## **HARMONY PLAZA SUBDIVISION**

***Revised for the February 21<sup>st</sup> meeting:***

# DETAIL SITE PLAN

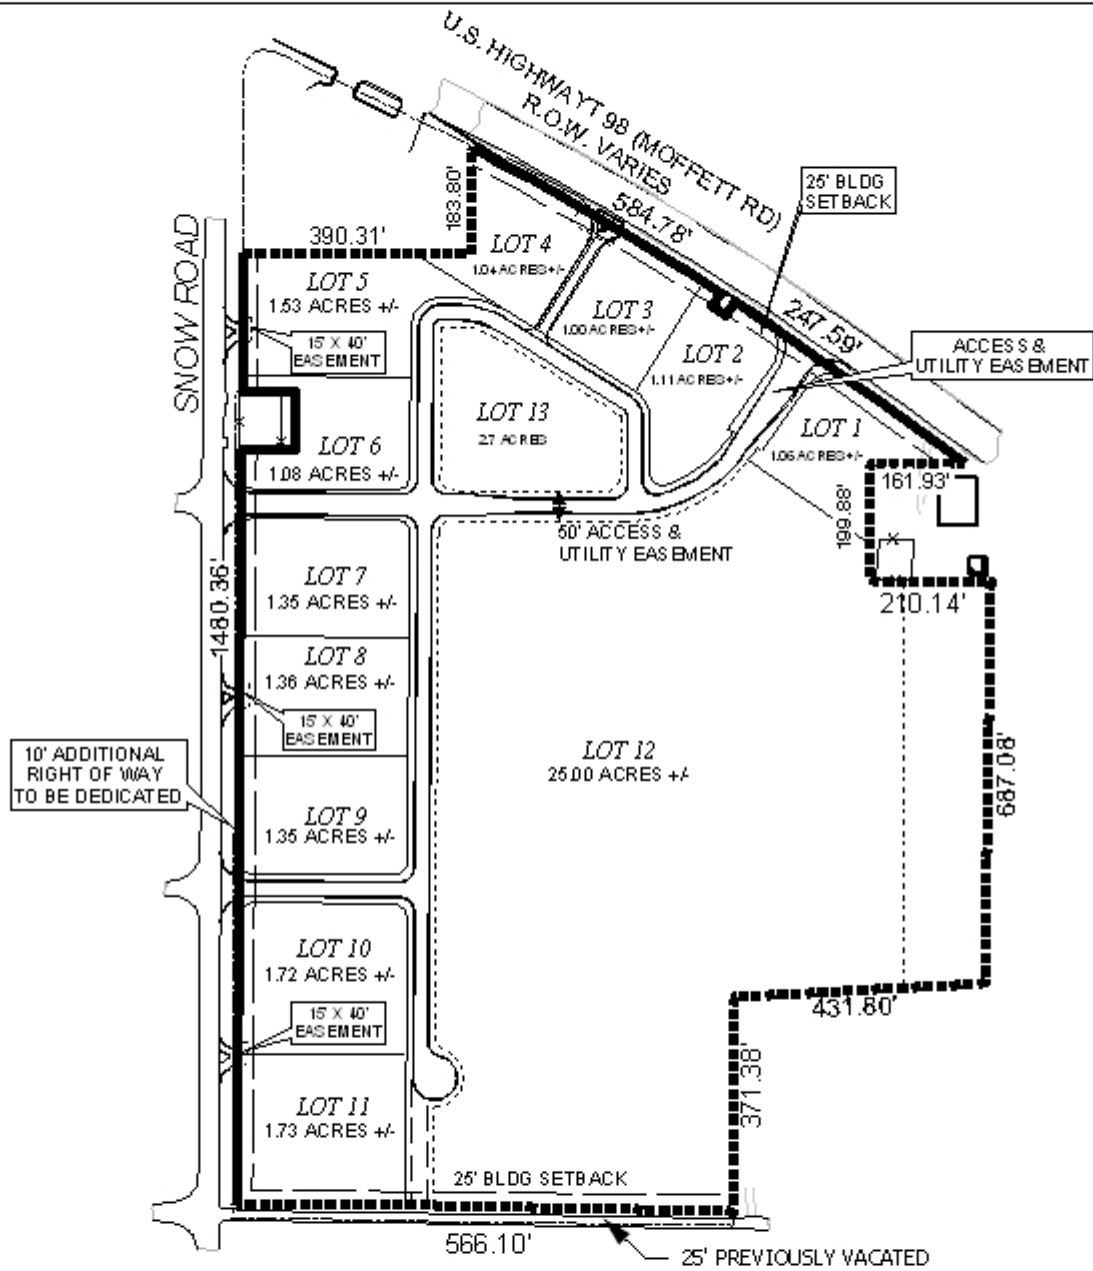
*According to the Impact Study, the existing roads provide adequate “levels of service.” However, there is no specification of the “peak” time that the study was conducted. It also does not take into account future growth that the proposed development would attract, which will greatly affect the “levels of service.” Due to the location of three schools, a park, and a community center all directly across from the subject site on Snow Road, it does not appear that the proposed curb cuts for the out-lots onto Snow Road will be compatible with the surrounding area. Furthermore, traffic issues already exist at the intersection of Moffett Road and Snow Road, especially between the hours of 7:00 – 8:00am and 2:30 – 3:30pm; thus access management and public safety are of major concern. It is the recommendation of staff and City of Mobile Traffic Engineering that all lots be denied direct access to Snow Road and Moffett Road, and the entire site should be limited to two curb cuts to both Moffett Road and Snow Road, as depicted by the “access and utility easement” on the preliminary plat.*

*As proposed, it appears that the “access and utility easement” is part of Lot 12; therefore, Lot 13 has no frontage on a public street. Section V.D.4 of the Subdivision Regulations requires that all lots abut a public street, unless a private street complying with Section VIII.E. of the Subdivision Regulations is provided. Therefore, the plat should be revised to either provide a public street, or a private street with private street right-of-way, complying with the requirements of Section VIII.E. of the Subdivision Regulations. Furthermore, if the easement is ever dedicated to the county as a public street, it must comply with the regulations of Mobile County Engineering.*

- 1) the dedication of a minimum of 50’ of right-of-way from the centerline of both Moffett Road and Snow Road;*
- 2) placement of a note stating that the entire site is limited to two curb cuts onto Moffett Road and two curb cuts onto Snow Road;*

- 3) placement of a note on the final plat stating that all lots are denied direct access to Moffett Road, Snow Road, and any access to the private street along the Southern boundary of the site;*

- 4) dedication of the “access and utility easement” as a public street per Section V.D.4. of the Subdivision Regulations, or as a private street complying with Section VIII.E. of the Subdivision Regulations; either shall be constructed to County Engineering Standards and the 2003 International Fire Code, and accepted by County Engineering prior to signing the final plat;*

- 5) labeling of lots with their sizes in square feet (in addition to acreage), or the provision of a table on the plat with the same information;*
- 6) placement of a note on the plat / site plan stating that approval of all applicable Federal, state and local agencies is required for endangered, threatened or otherwise protected species, if any, prior to the issuance of any permits or land disturbance activities;*
